**PCN# 20250404000.2**

**Qualification of LFAB as an additional Wafer Fab site option for select devices  
Change Notification / Sample Request**

**Date:** April 04, 2025

Sample product shipping label (not actual product label)

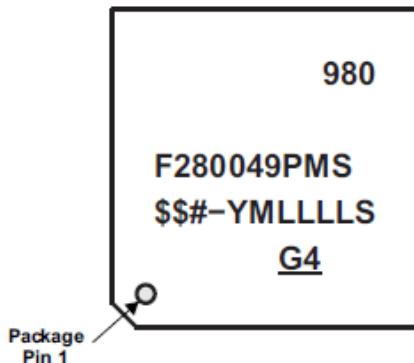
**Changes to product identification resulting from this PCN:**

YMLLSS = Lot Trace Code

\$\$ = Wafer Fab Code (one or two characters) as applicable

# = Silicon Revision Code

**Updated Wafer Fab Code:**

\$\$ = YF → TSMC-F14

Or

\$\$ = 3L → LFAB

**Updated Silicon Revision Code:**

# = B

Or

# = D
